Block 16 Section 10

1.0 Context and Character

Diversity and amenity Apartment depth

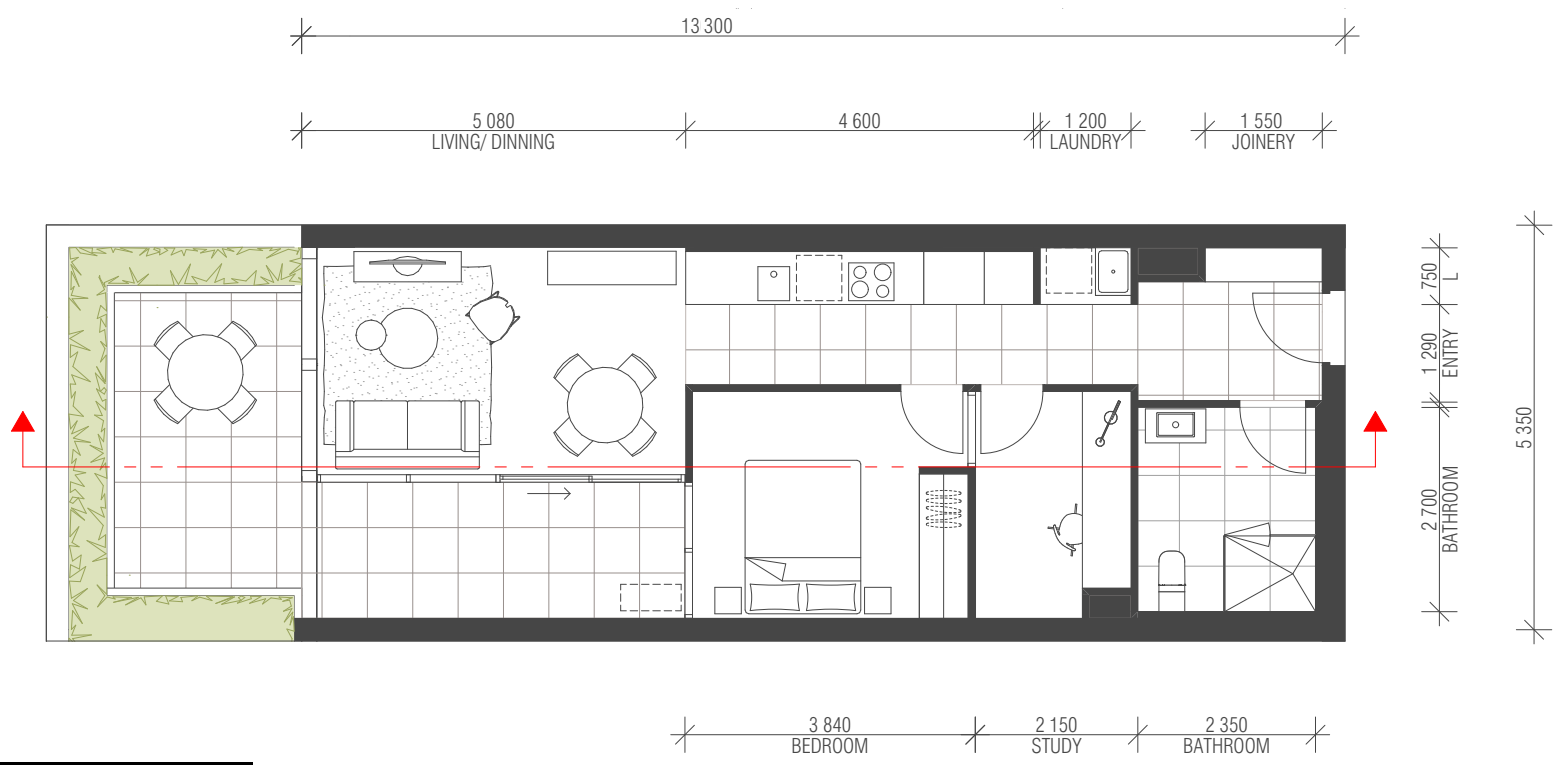
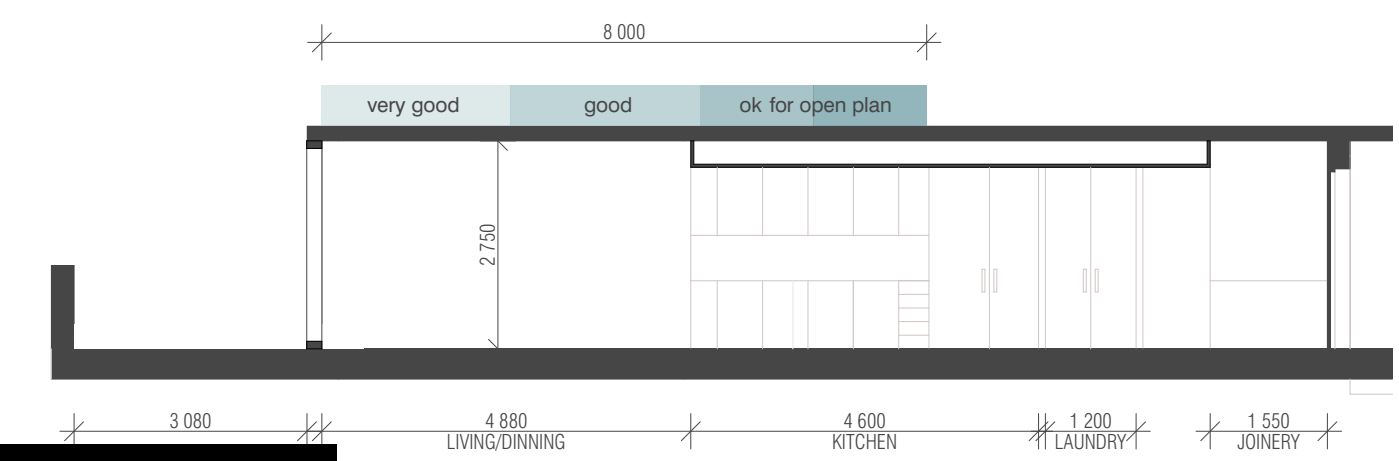
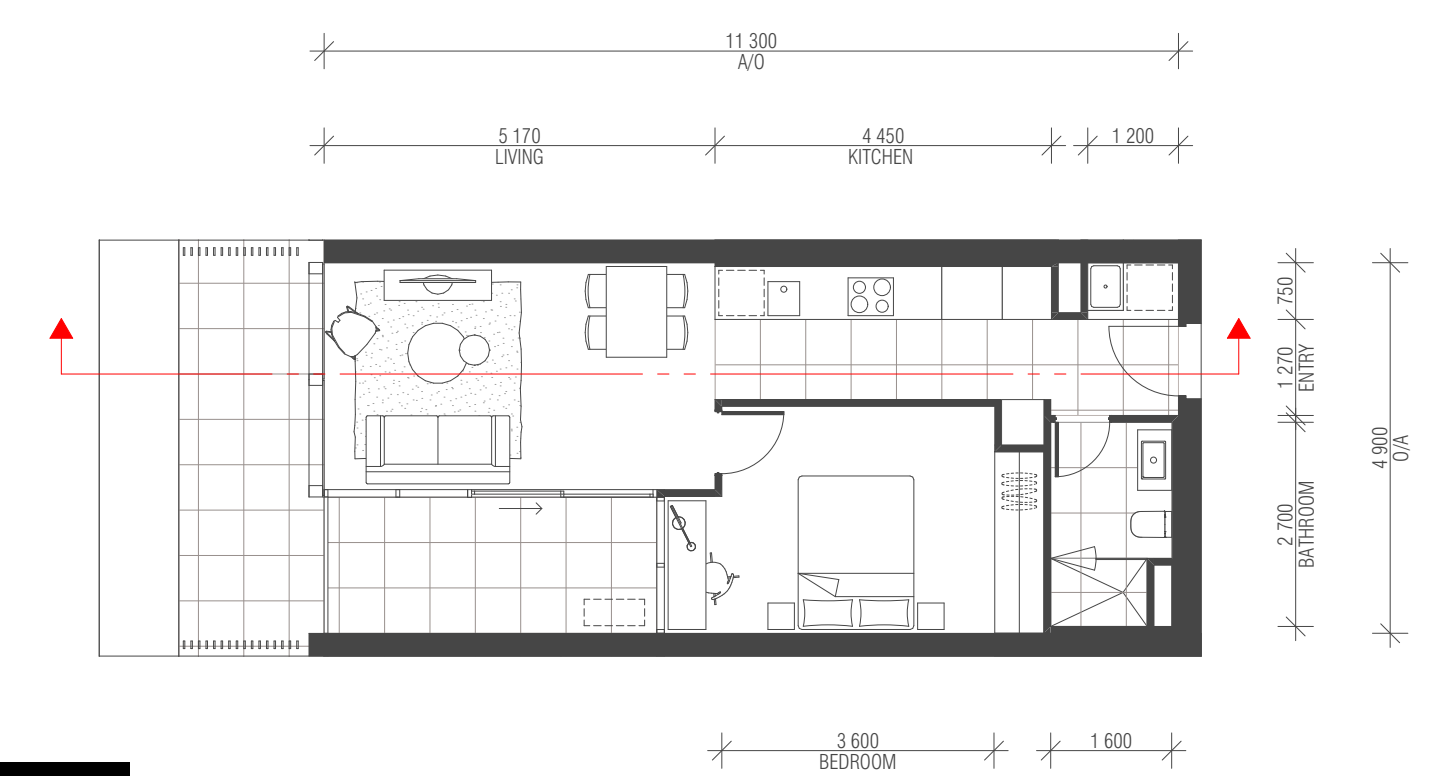
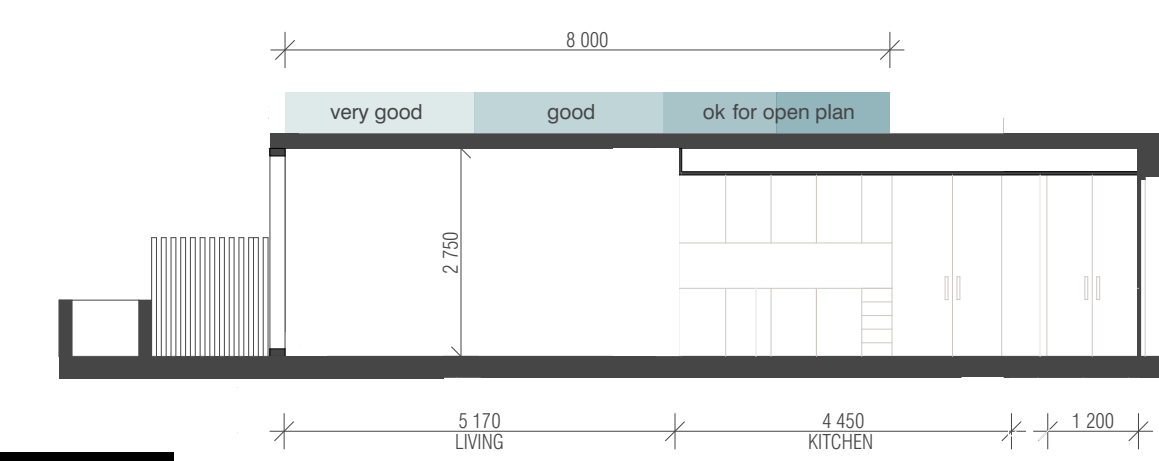
8.1 The amenity of the proposed apartment layouts generally is considered by the Panel to require further design development with a greater emphasis on natural cross ventilation and access to direct daylight to habitable rooms. Although the Panel acknowledges that some of the proposed design arrangements can generate functional outcomes such as reduce wind impact to balconies, the Panel:

8.1.1 considers the overall building floor plate depth to be impacting the quality of apartment designs;
 8.1.2 questions the adequacy of access to light and natural ventilation where bedrooms are located beyond deep balconies, which are then compounded with borrowed light

Diversity and amenity Apartment depth

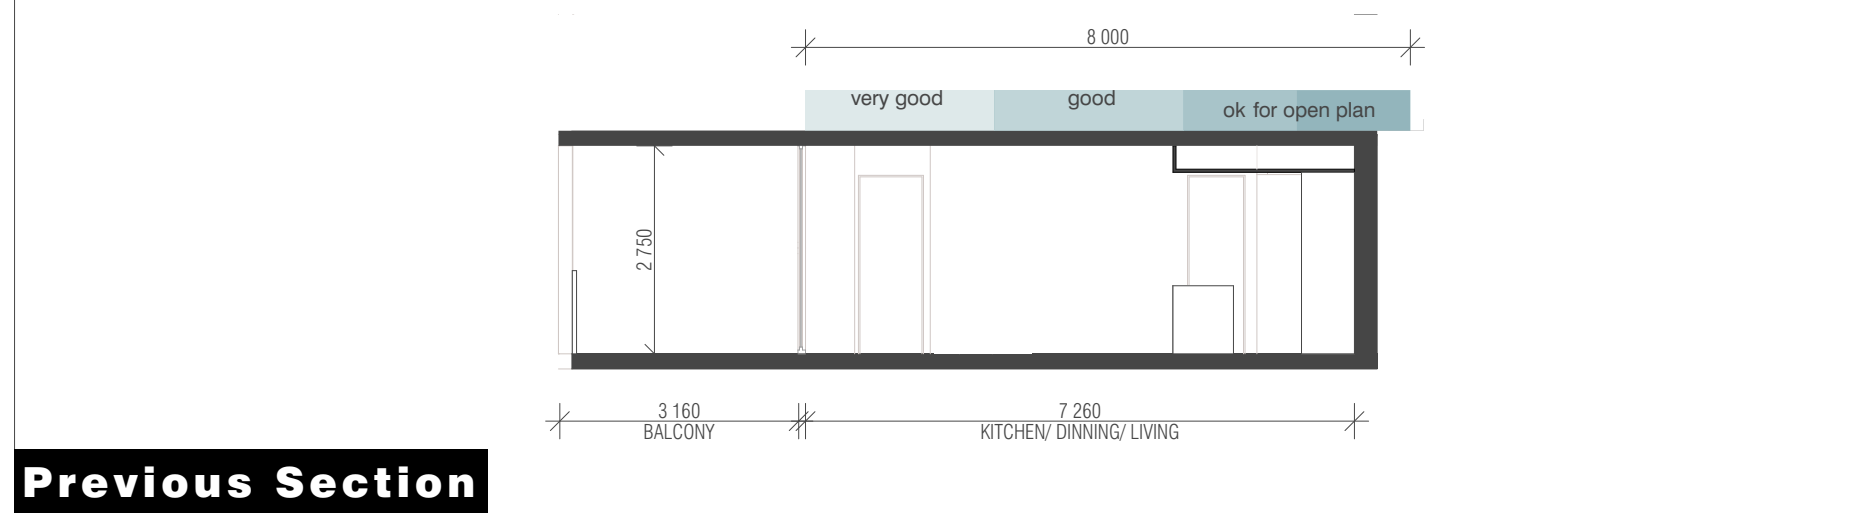
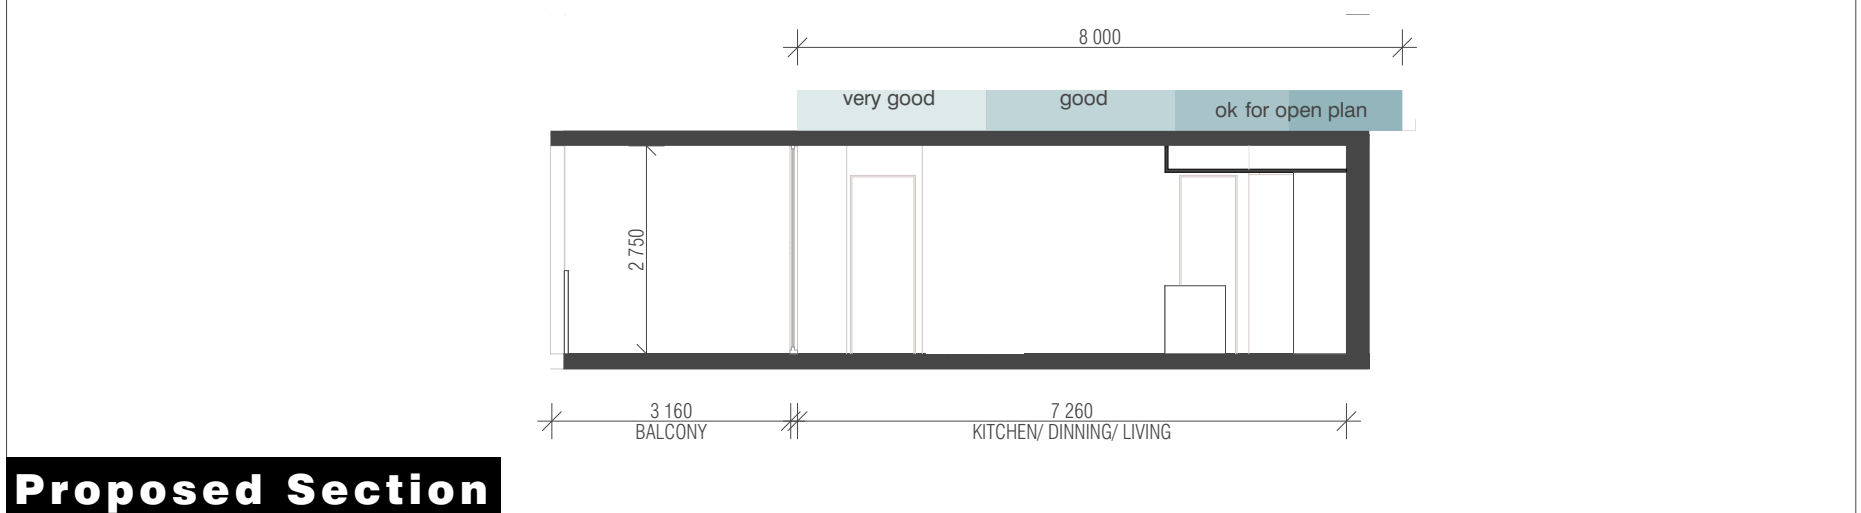
8.1 The amenity of the proposed apartment layouts generally is considered by the Panel to require further design development with a greater emphasis on natural cross ventilation and access to direct daylight to habitable rooms. Although the Panel acknowledges that some of the proposed design arrangements can generate functional outcomes such as reduce wind impact to balconies, the Panel:

8.1.1 considers the overall building floor plate depth to be impacting the quality of apartment designs;
 8.1.2 questions the adequacy of access to light and natural ventilation where bedrooms are located beyond deep balconies, which are then compounded with borrowed light

Diversity and amenity Natural ventilation

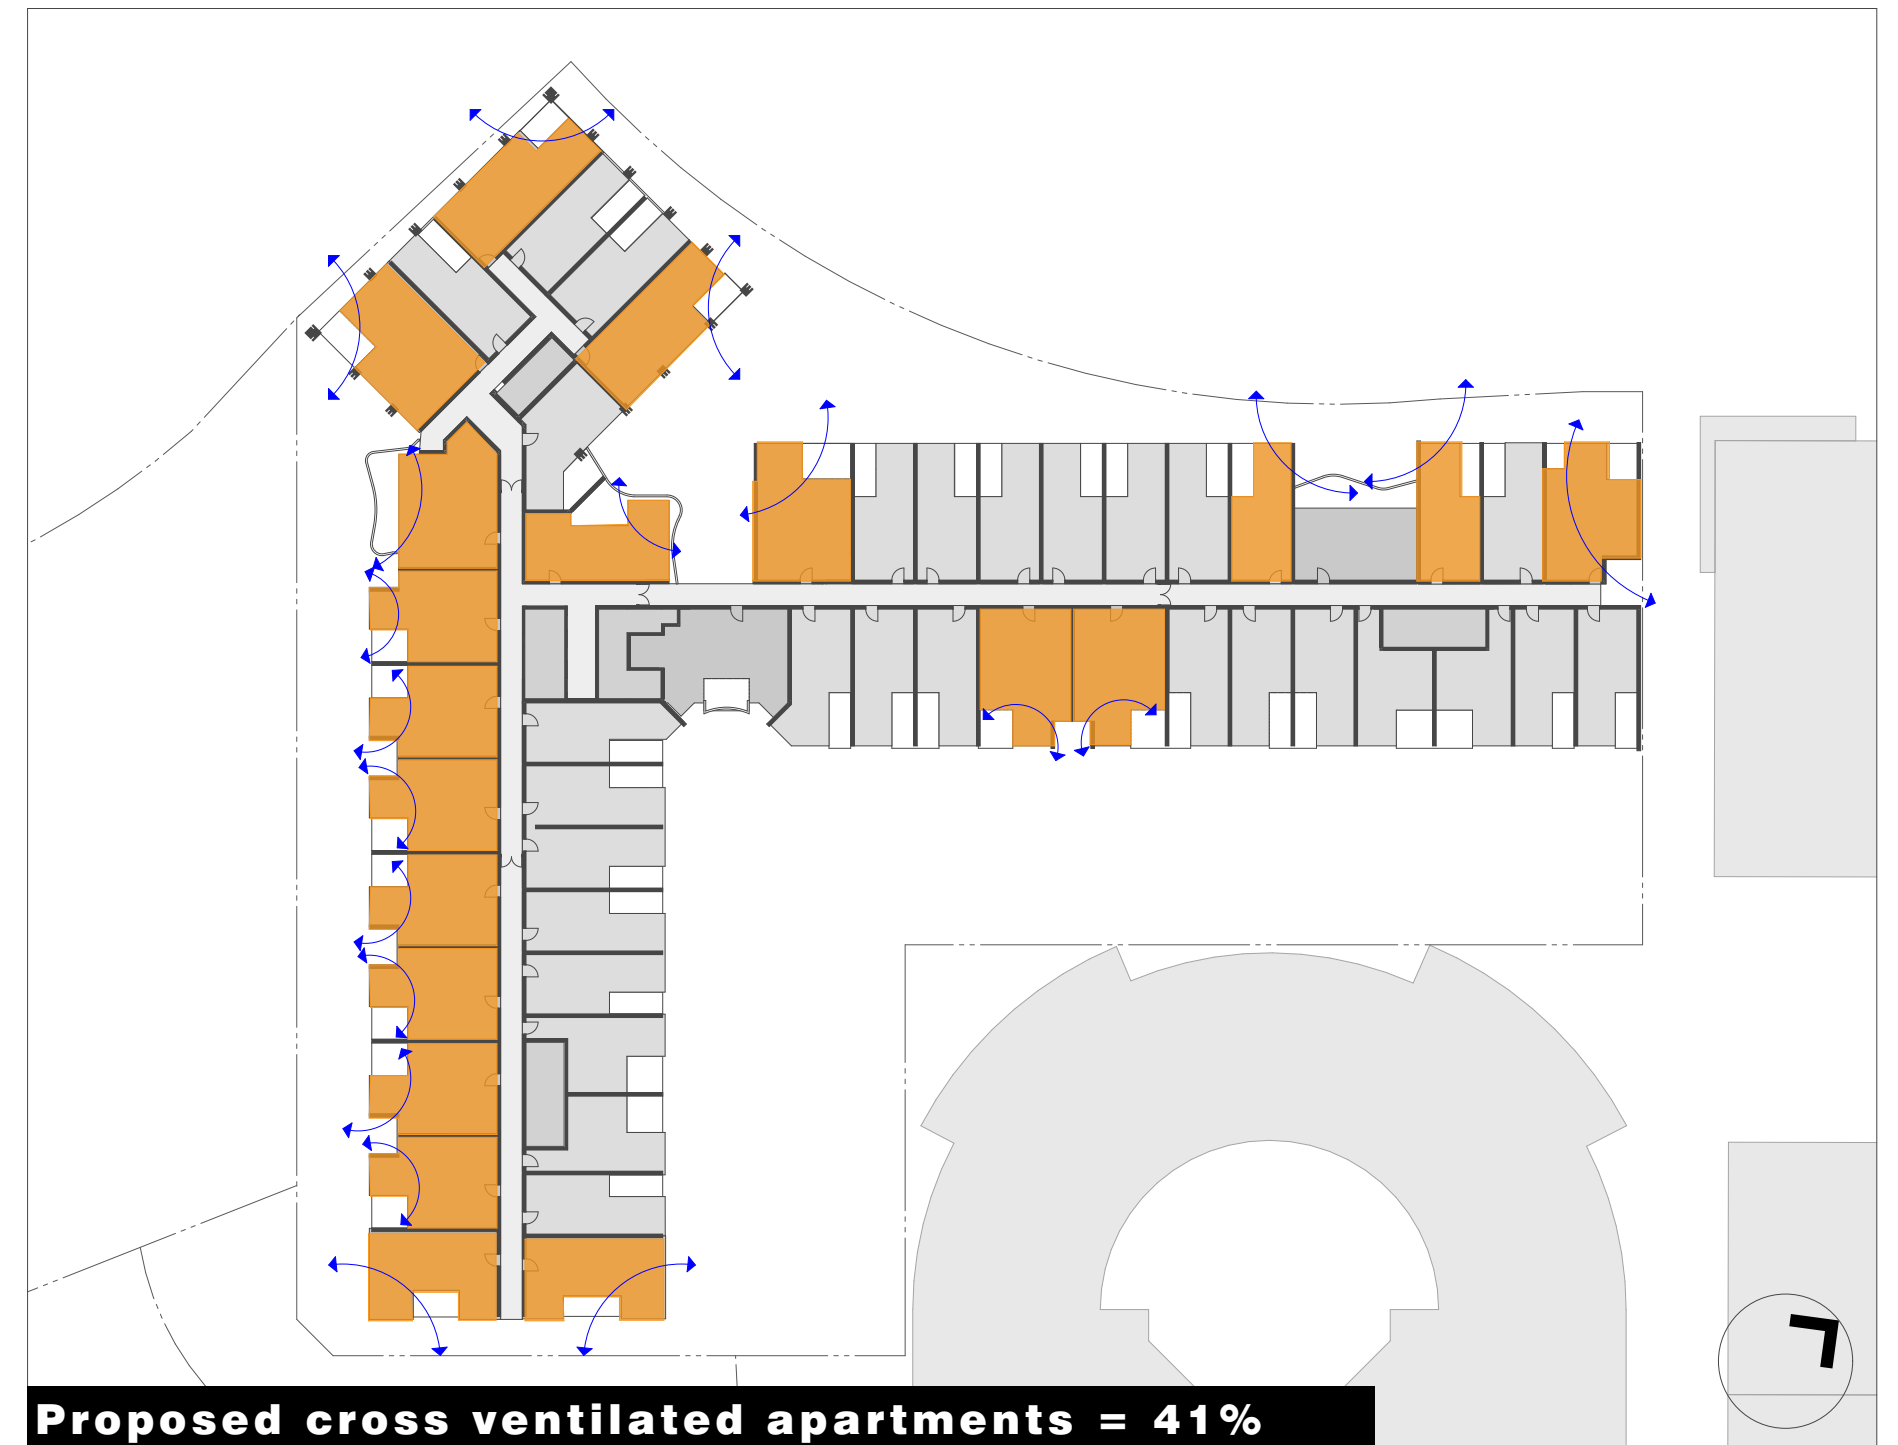
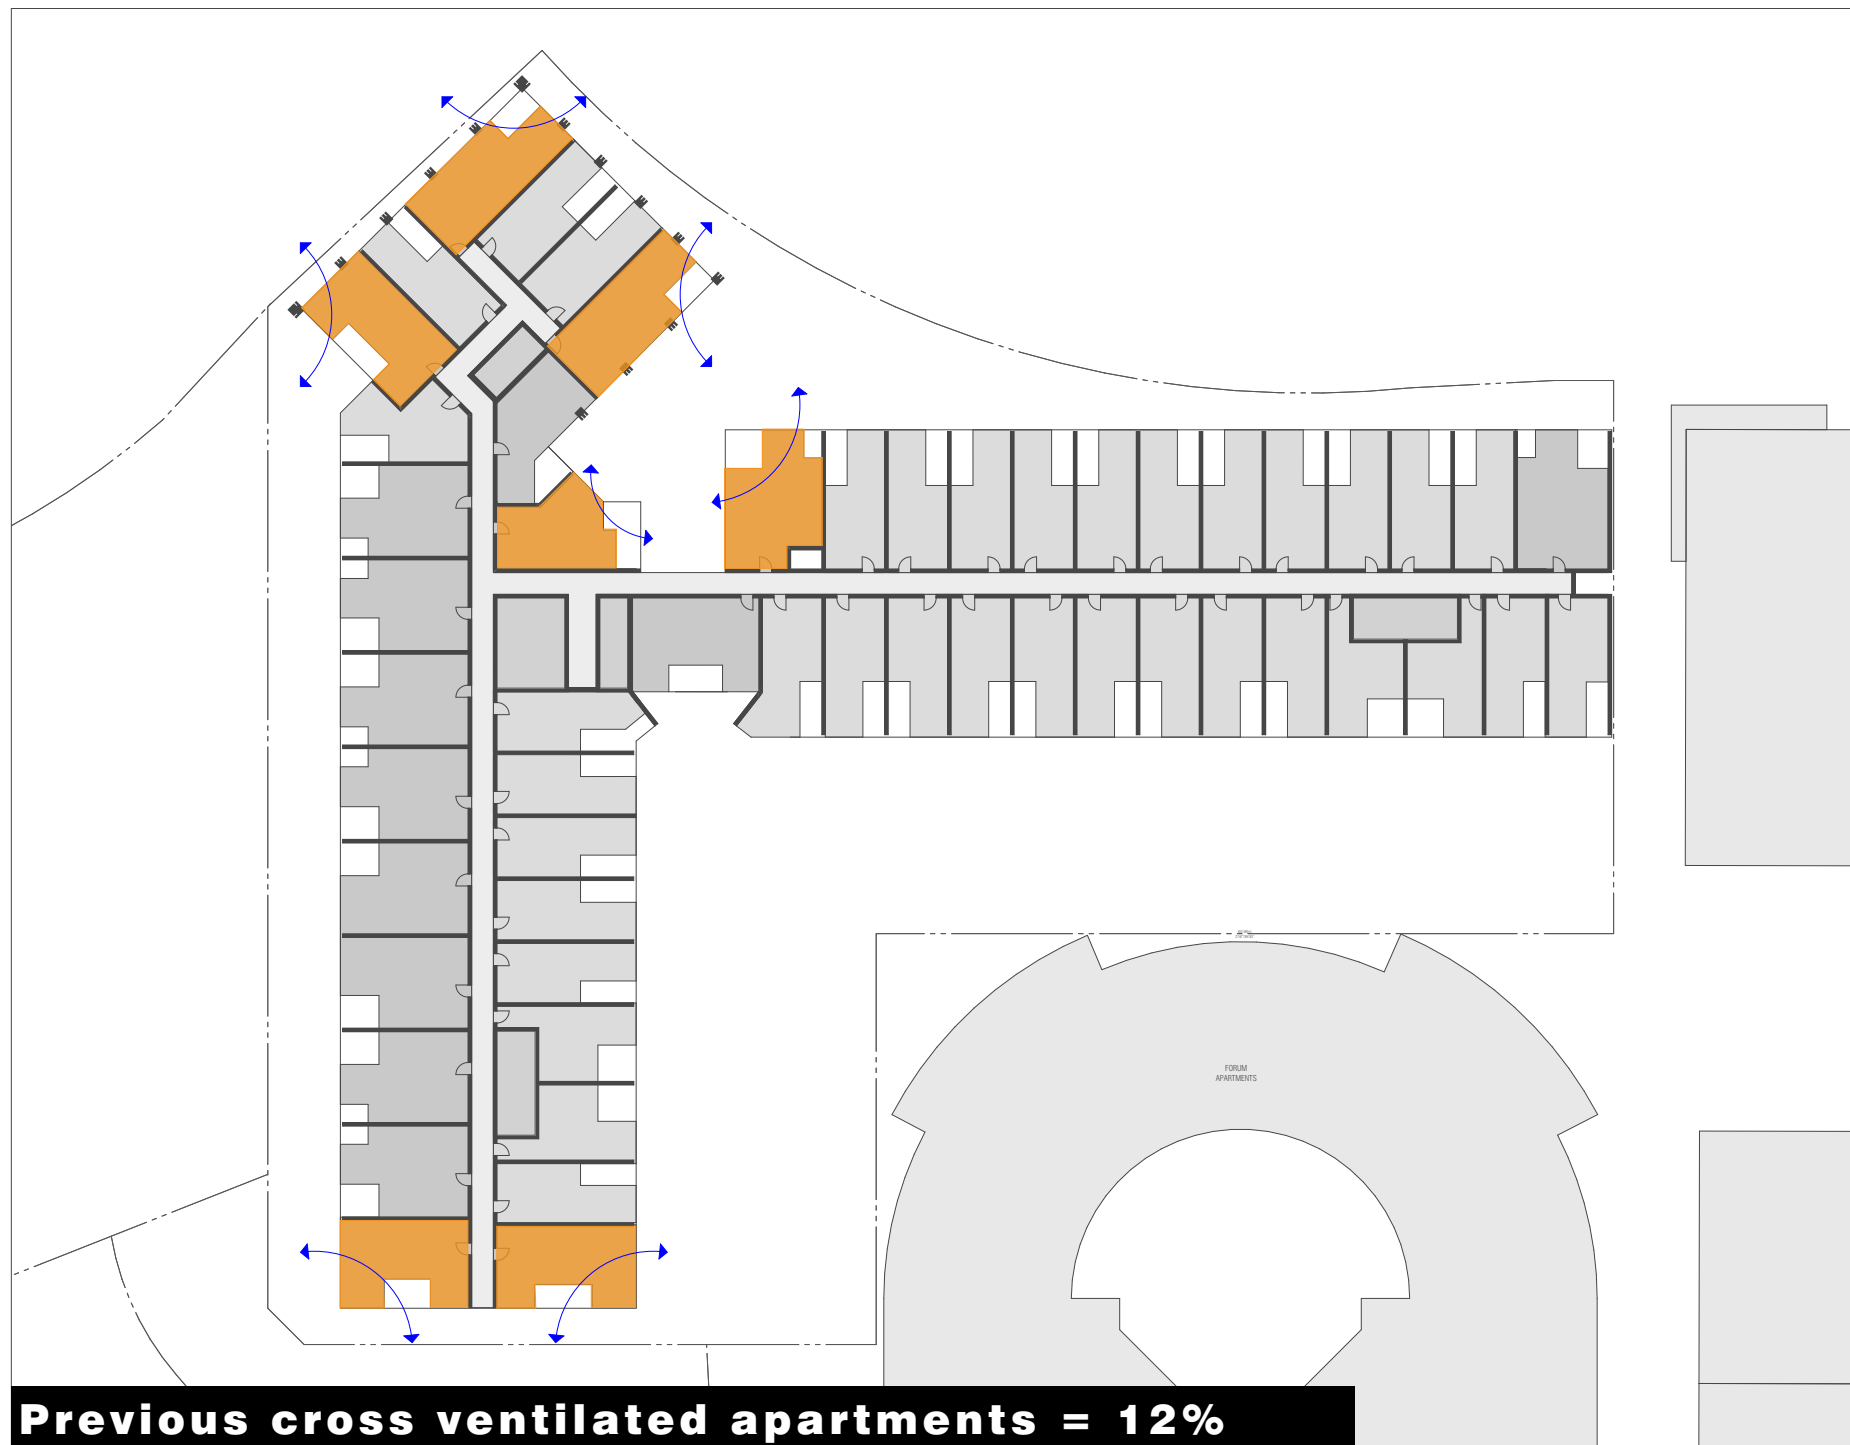
8.1.3 recommends that a greater percentage of apartments are required to achieve natural cross flow ventilation such as provision of dual aspect apartments (i.e. corner or through style apartment layouts);
